**[Docket No. FAA-2012-0060; Directorate Identifier 2012-NE-02-AD; Amendment 39-17123; AD 2012-14-09]**

#### **Airworthiness Directives; Pratt & Whitney (P&W) Division Turbofan Engines**

**ACTION:** Final rule.

Figure 1 to Paragraph (e) - Determination of Vane Eligibility

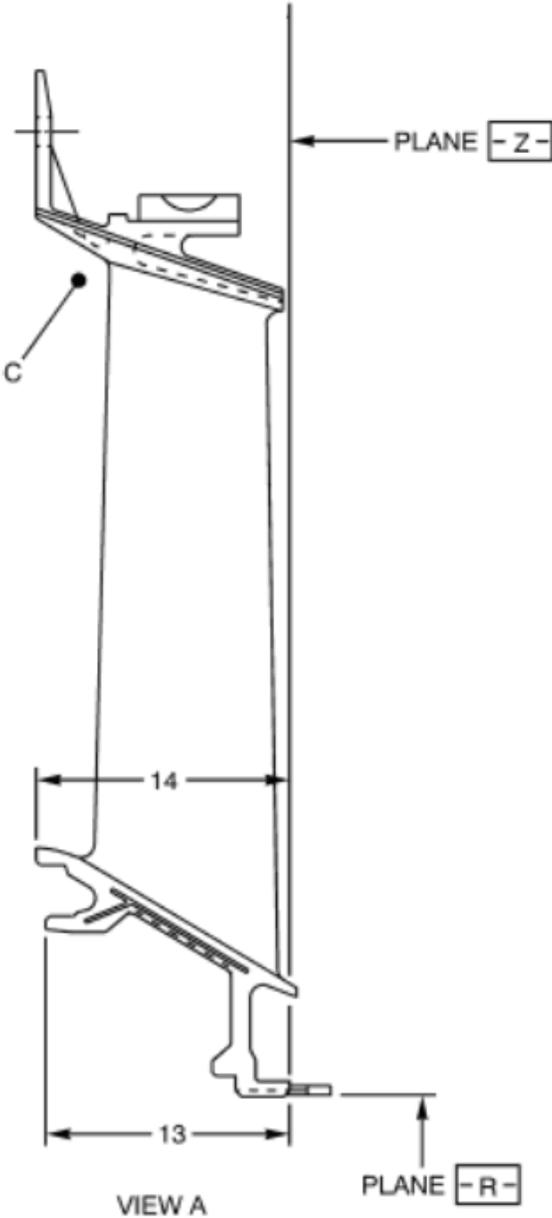
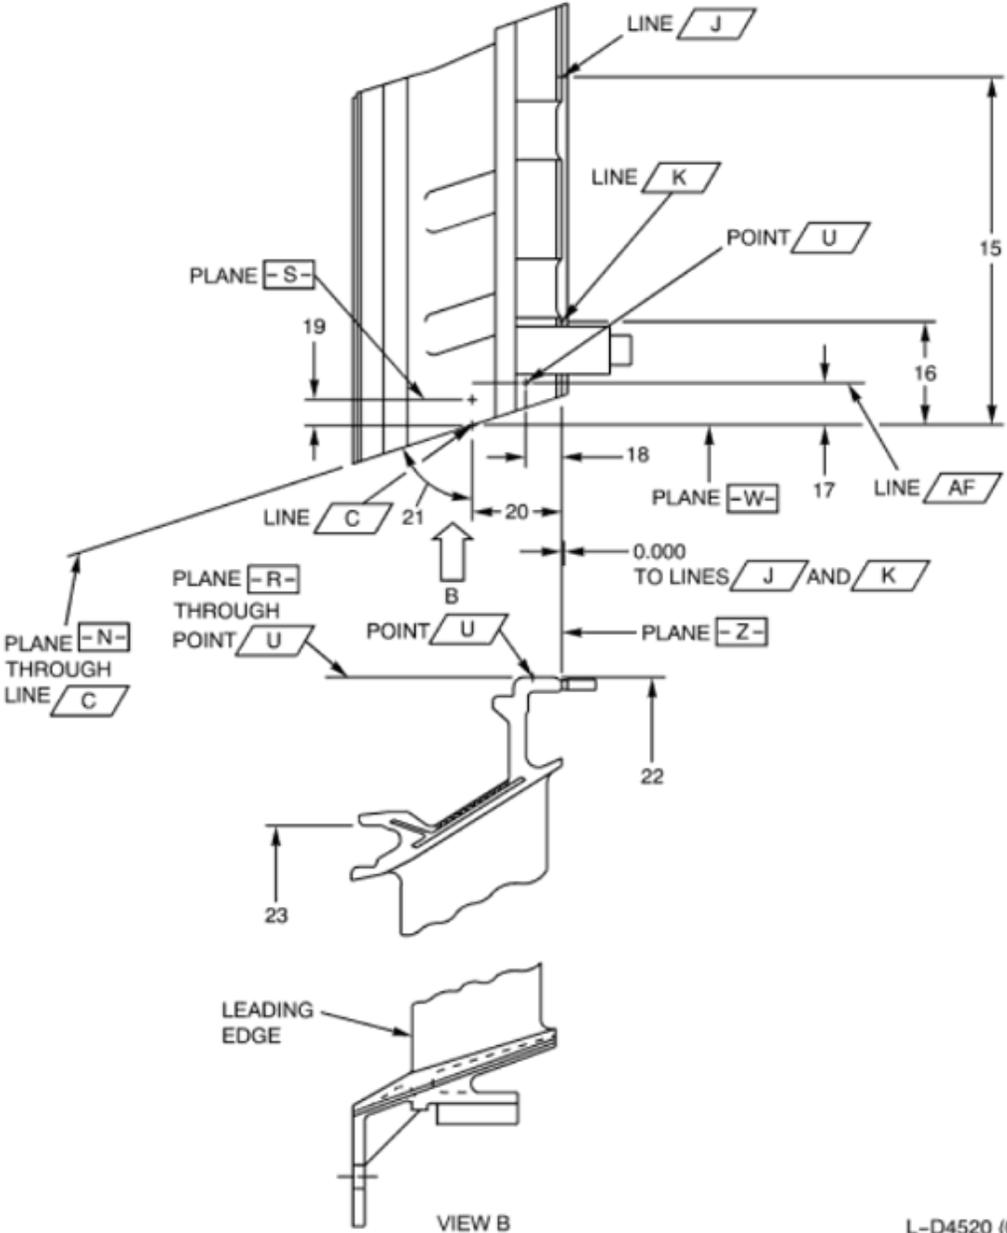
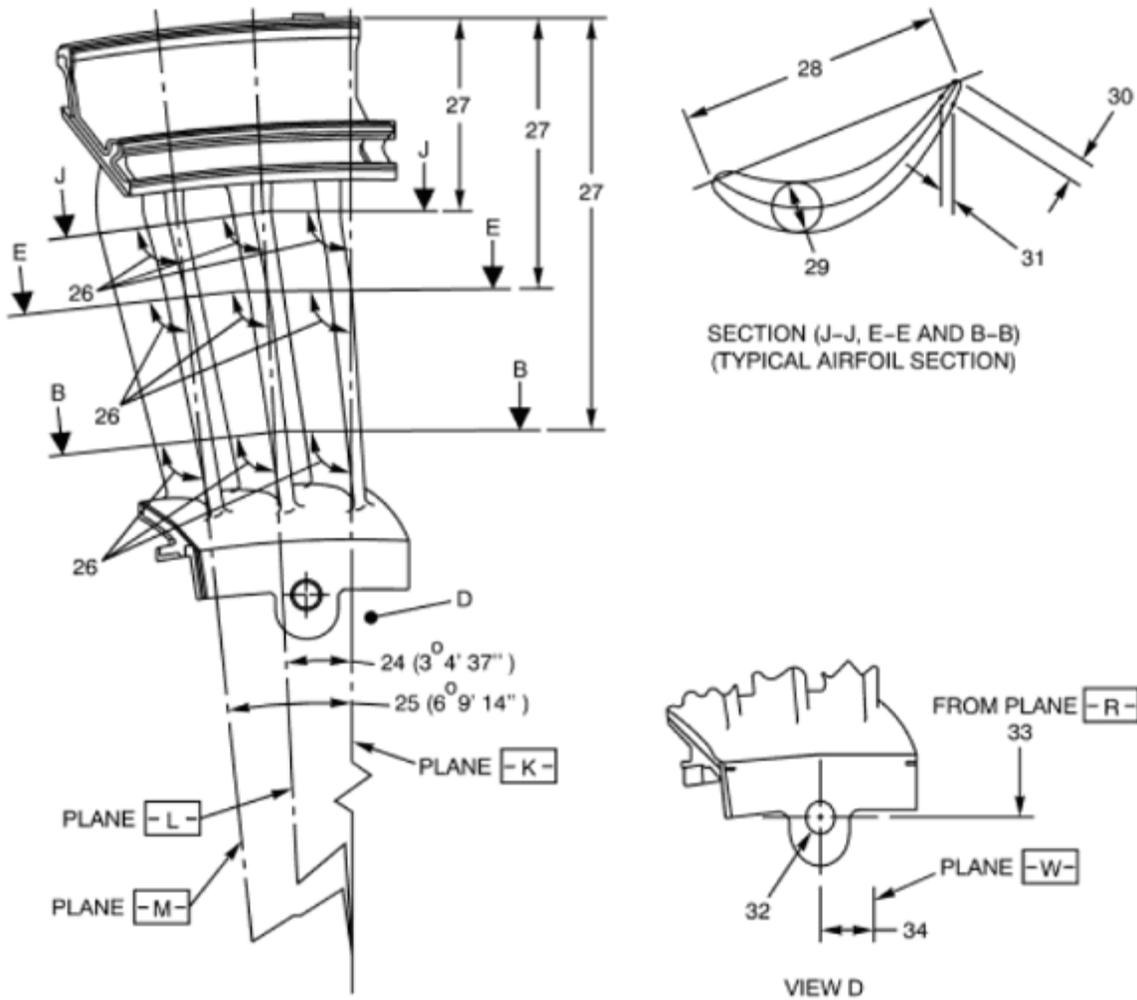
United Airlines requested that in proposed AD paragraphs (e)(1)(iii) and (e)(1)(iv), we change "ensure adequate engagement" to "dimensionally inspect the applicable LPT case slot serviceable dimensions and 3rd stage vane serviceable dimensions per the appropriate CIR." The commenter also requested that we list the specific dimensions to inspect by index number. The commenter stated that no mechanic can deduce what an adequate engagement is because it is not specific enough.

We agree. We changed paragraph (e)(1)(iii) to "dimensionally examine index 13 through index 34 of the LPT 3rd stage vane cluster assembly." We also changed paragraph (e)(1)(iv) to

"dimensionally examine index 23 and index 24 of the vane engagement slots on the rear turbine case, where the 3rd stage vane is installed." We also listed the specific dimensions to inspect by index number, and included the supporting figures in this AD.

(iii) Dimensionally examine index 13 through index 34 of the LPT 3rd stage vane cluster assembly. Use Table 2 to paragraph (e) of this AD and Figure 1, Figure 2, and Figure 3 to paragraph (e) of this AD to determine whether the vane is eligible for installation.
